CORRESPONDENCE SUMMARY

SUBJECT: Confirmation of Substantial Conformance for ZMAP-2009-0005, SPEX-2009-0009 & CMPT-2009-0001 (Green Energy Partners/Stonewall Hybrid Energy Park)

Re: Request for determination of Substantial Conformance
Green Energy Partners/Stonewall Hybrid Energy Park
ZMAP 2009-0005, SPEX 2009-0009 & CMPT 2009-0001
/60////////38/ (MCPI# 193-38-4362)
/60////////38A/ (MCPI# 193-49-0539)
/61////////12/ (MCPI# 193-39-3665)
/60////////39/ (MCPI# 194-48-6020)
/61////////14/ (MCPI# 193-29-6778)

SUBSTANTIAL CONFORMANCE EXHIBIT -B

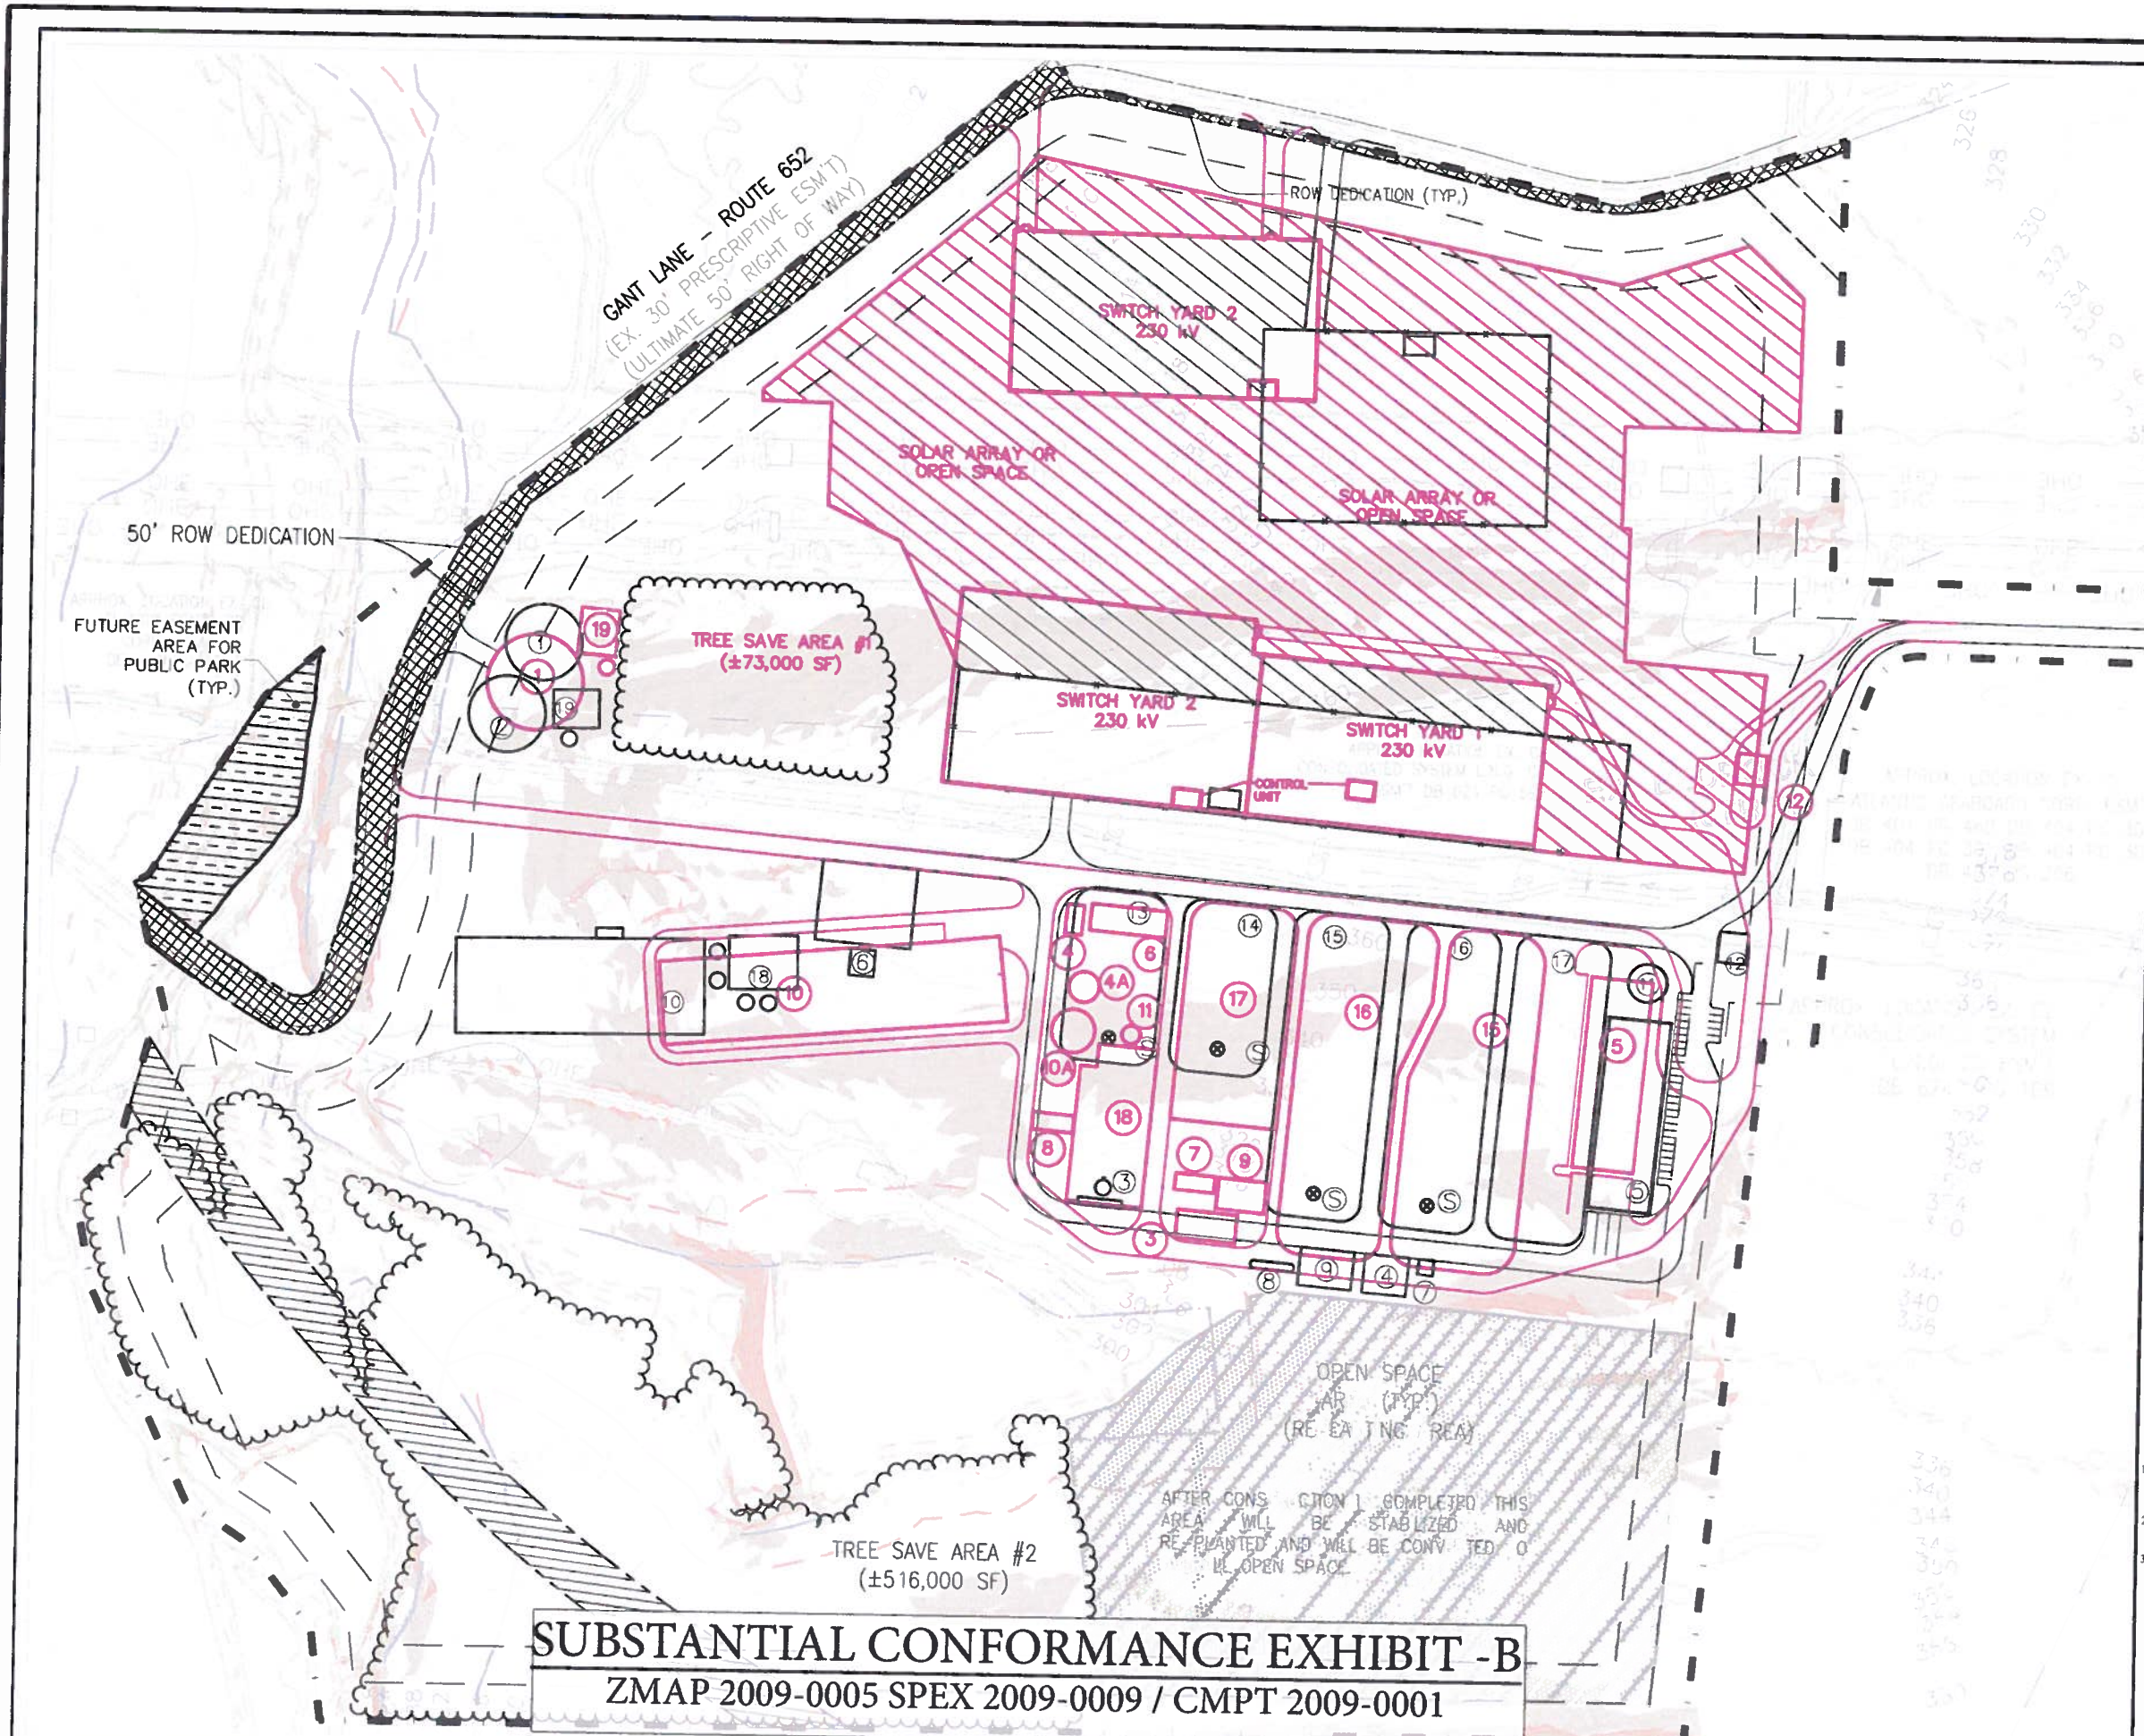
1. **Proffer I. 1. Substantial Conformance:** The heights listed in the Key on sheet 5 of 6 of the approved CDP apply for all structures. Exhibit B does not grant permission for taller structures, only the horizontal shifting of structures. Switchyard 2 may only be utilized in 1 location (final location to be determined at site plan).

2. **Proffer II.5. Reservation of Right-of-Way for Future Dedication – Cochran Mill Road, Relocated** – Please label at time of site plan.

3. **Proffer III.10. River and Stream Corridor Resources Management:** The revised location of the steam turbine (Key #17), aqueous ammonia storage, emergency generator and auxiliary boiler (Key #3, 7 and 9) results in land disturbance activities closer to the 50 foot management buffer than shown on approved ZMAP 2009-0005/SPEX 2009-0009/CMPT 2009-0001. At time of site plan, the applicant must demonstrate compliance with Proffer III.10. River and Stream Corridor Resources Management.

4. **Proffer V. 19. and Condition #25 Emergency Access:** The redesign of the Guard House/Visitor Center (Key #12) may not interfere with Fire and Rescue Emergency access.

5. **Condition #16 Very Steep Slopes Areas**: The revised location of the combustion turbine HRSG#2 (Key #15) results in land disturbing activities closer to the existing very steep slopes than shown on approved ZMAP 2009-0005/SPEX 2009-0009/CMPT 2009-0001. At time of site plan, the applicant must demonstrate compliance with Condition #16 – Very Steep Slopes.

6. **Condition #18: A minimum of 65% Open Space shall be provided on the Property.** The final travel way location may not encroach into the Open Space/Replanting Area located to the south of the travel way and the Multimedia Water Filters (Key #19) may not encroach into

the adjacent Tree Save Area #1. At time of site plan, the following open space areas shall be labeled:

a. "Open Space Area" – between the future easement area for the Public Park and Gant Lane.
b. "Open Space Replanting Area" – between the Cochran Mill Right of Way reservation and cooling tower (Key #10).

Determination:
The revised location of the Emergency Fire Pump is in substantial conformance with the approved CDP.

The emergency generator fuel source has been changed to diesel fuel and is in substantial conformance with the Proffers, Conditions of Approval, and CDP. Diesel fuel shall be used only to fuel the generator and not for the production of electric power per SPEX Condition #9. See Attachment A regarding Loudoun County's policy on Stormwater "Hotspots". The emergency generator will be considered a Stormwater Hotspot and subject to the Loudoun County Facilities Standards Manual, Section 5.320.E.4 at site plan submission.

Determination:
The Hydrogen Storage Tank is in substantial conformance with the Proffers, Conditions of Approval, and CDP and must comply with all Local, State and Federal standards and guidelines.

Determination:
The location of the pole mounted solar array is in substantial conformance with the Proffers, Special Exception Development Conditions, and CDP provided that it is located within the solar array/open space area.

A portion of the Guard House/Visitor Center (Key #12) is not located in the solar array/open space area (final location will be determined at time of site plan). If a solar array is provided on the Guard House/Visitor Center it must be located on the portion of the structure located in the solar array or open space area. The maximum height may not exceed the height shown in the Key on sheet 5 of 6 of the approved CDP.

Determination:
The changes listed in the July 18, 2012 letter and shown on Substantial Conformance Exhibit-B ZMAP 2009-0005/SPEX 2009-0009/CMPT 2009-0001, are found to be in substantial conformance with the approved Concept Plan and Special Exception Plat. It is noted that compliance with the items listed below must be demonstrated at time of site plan.
